US 63165780-01

Residue inside instrument cluster lens

K48 OLD

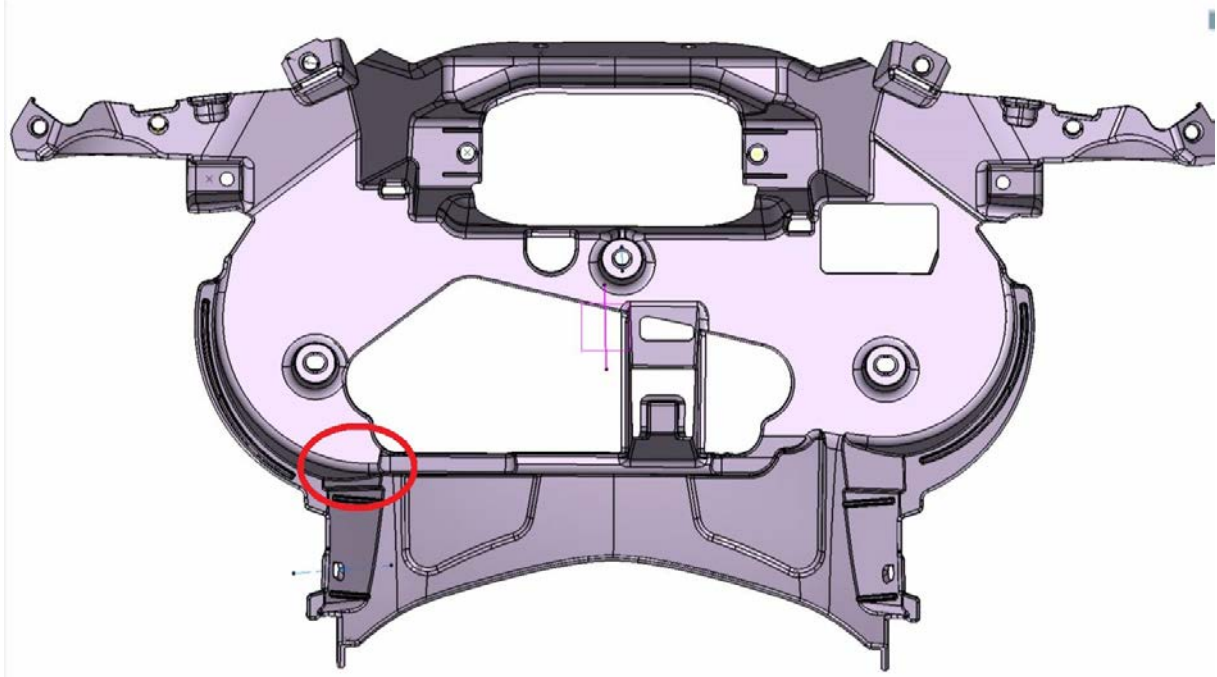
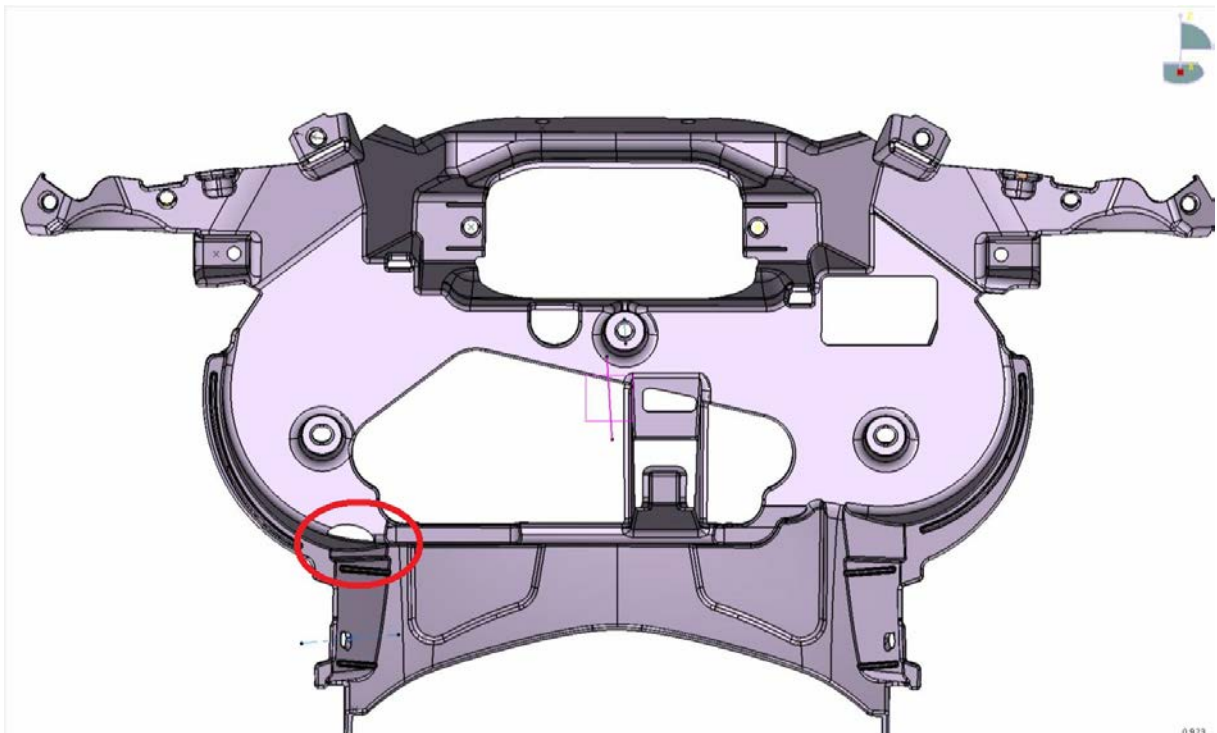
If fogging has repeatedly occurred in the instrument cluster of K48 and K52 models and water drop residue remains after drying (See Attachment), the instrument cluster support must be replaced in addition to the lens (repair kit).

For visual differentiation between model K48 and K52 instrument cluster support, old and new status, see attachment.

K48 (K1600 GT/GTL/GTLE):

Part number 46 63 7 710 443

When removing the instrument cluster in K48 models, the support of the instrument cluster is to be removed jointly with the instrument cluster. For this purpose, only flat nuts and rubber grommets need to be attached to the new support.

K52 OLD

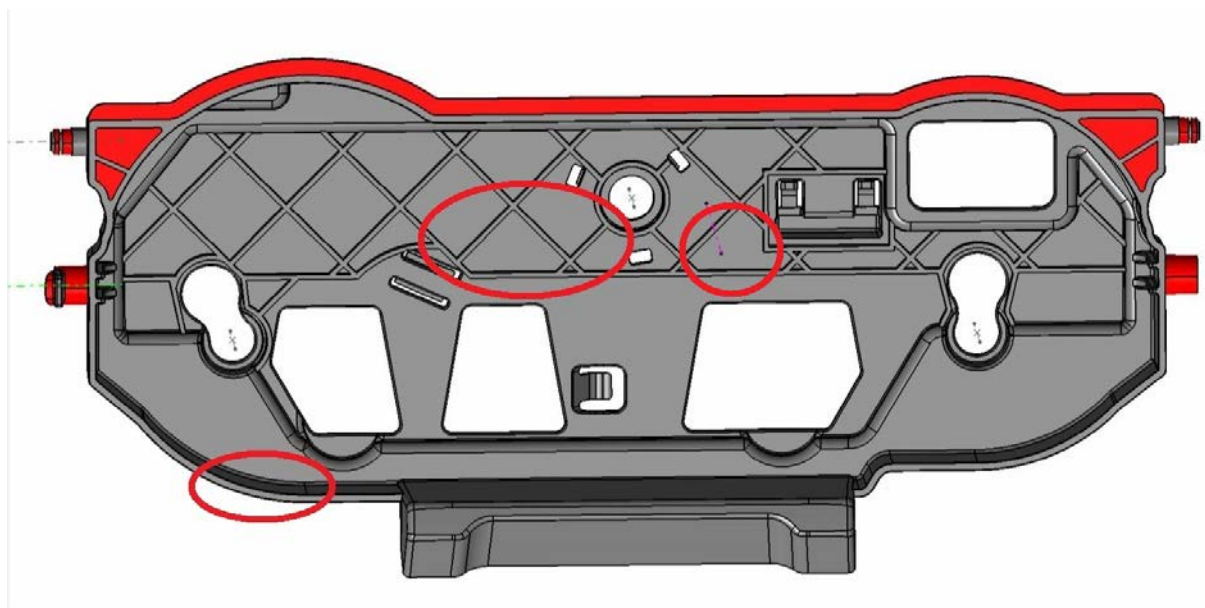
K52 (R1200RT):

Part number 46 63 8 529 392

For K52 model, the support of the instrument cluster must be removed and replaced separately.
